FlexPLI Manual

FlexPLI Preparation before Car Testing

Proposal

On behalf of OICA, provided by:

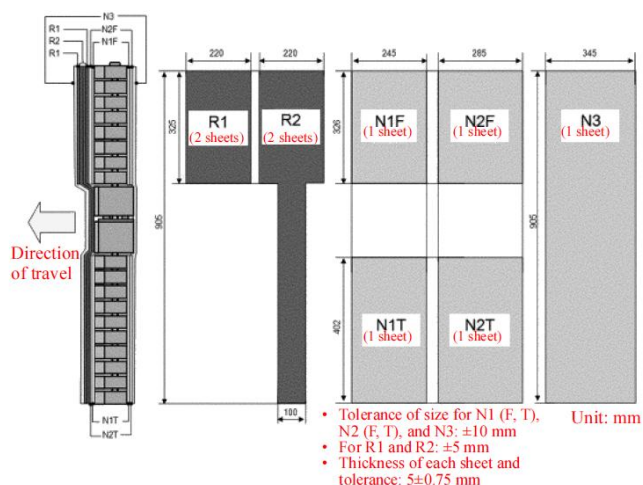
- N3: Neoprene, outer cover
 N2: Neoprene, second layer *
 N1: Neoprene, first layer *
 R2: Rubber, second layer
 R1: Rubber, first layer

* suffix F = femur part, suffix T = tibia part

Step 1: Place the large outer cover (N3) on the bench with lettering face down. Lay 6 strips of Velcro tape over with fluffy side down, then place the rubber buffer sheet assembly 133-5020 over the strips (R1, R2 (2sheets), R1). The large rubber part goes to the top of the leg; this is the side where the hanger for dynamic testing is attached. Adjust the tape so that all the Velcro strips line up with the six markers on the rubber see Figure 73. Lay Thigh 2 and Leg 2 covers (N2F, N2T) over, with the two knee end inside arrows pointing towards each other allowing a gap for the knee area then do the same with Thigh 1 and leg 1 covers (N1F, N1T) .

- the lower edge of the rubber parts R1 and the femur neoprene parts (N1F, N2F) shall align with the upper end of the knee block
- the recess of the rubber parts R2 shall align with the upper end of the knee block
- The upper edge of the tibia neoprene parts (N1T, N2T) shall align with the lower end of the knee block
- The outer cover N3 shall be centered to the leg assembly without hangers and ballast weights

Figure 16 . Leg manipulations for positive output

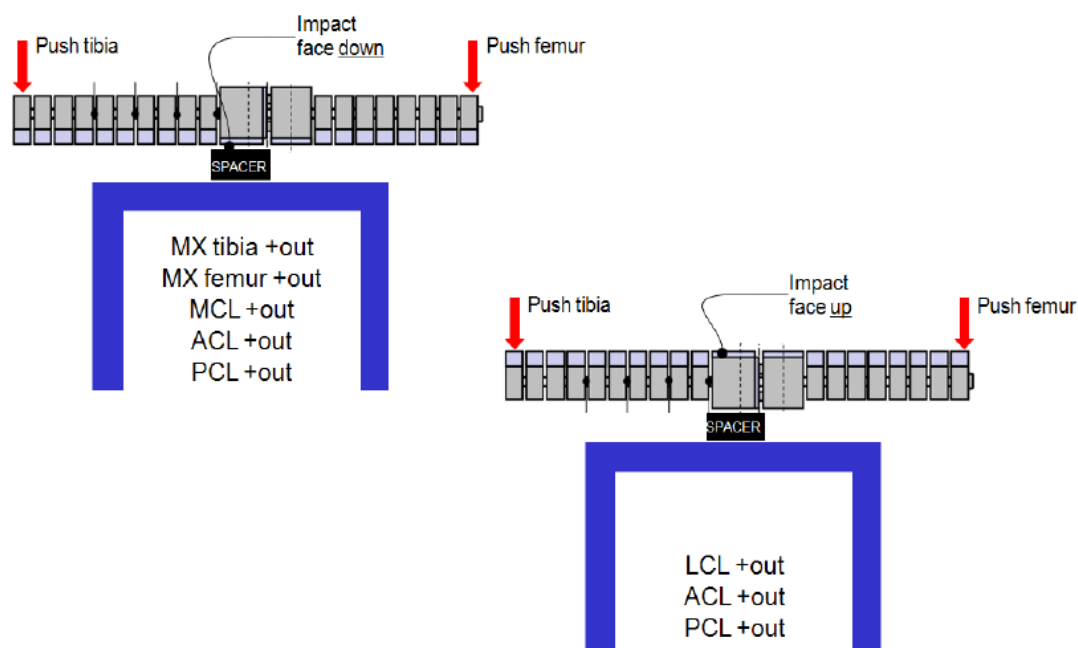
- Step 5: Check all segment screws and side aluminum shoulder screws are tightened to 3 Nm
- **Step 6:** Hook up the sensors on the Data Acquisition System (DAS) **and check the sensor polarities (Section 2.3.2 and figure 16) by flexing the leg**

Polarity check must not be done repeatedly before each test

- Step 1: Hook up the sensors on the Data Acquisition System (DAS)
- Step 2: Fit the leg to the pivot block on the rig using the M10 Socket Head Shoulder Screw (SHSS). Route the disconnect wire as required out of the end of the tibia or below the knee depending on type of DAS and tape up to the rig so that it does not interfere with the free swing motion of the leg when tested. If using off board DAS the wires are routed out of the top of the leg.
- Step 3: With the leg hanging down vertically, start up and initiate the DAS and set the DAS such that the sensors are zeroed to zero sensor output in this position. Important: The leg sensors are zeroed in the vertical impact position before lifting to 15 degree above horizontal.

Figure 60 . Knee Assembly, Exploded View

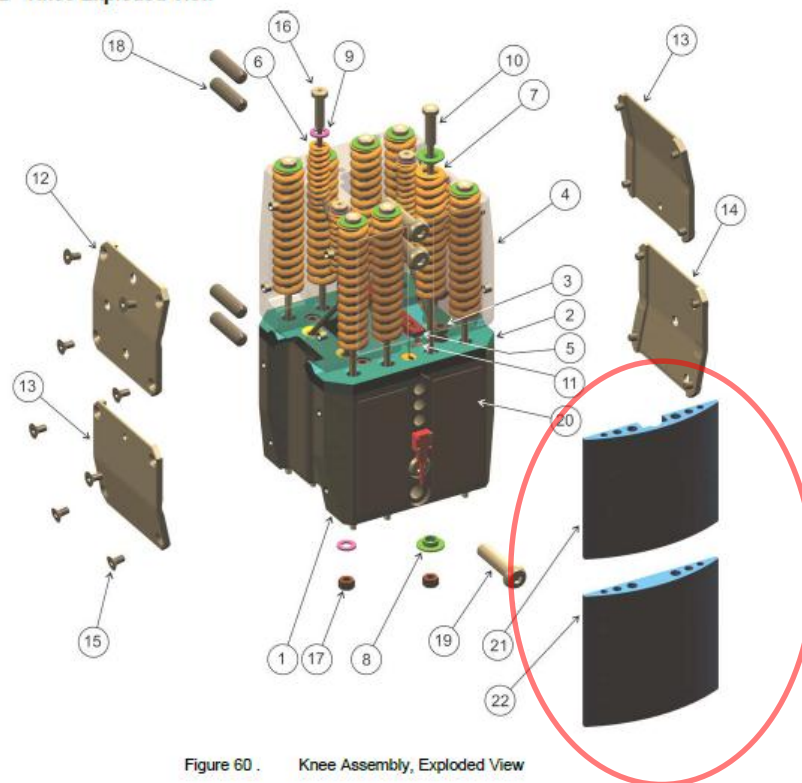
- **Step 1:** Check alignment of upper and lower knee covers (133-5304, 133-5305)
- **Step 2:** Check the eight M8 set screws shown in Figure 88 are tightened to 8 Nm

Check alignment of upper and lower knee covers (133-5304, 133-5305)
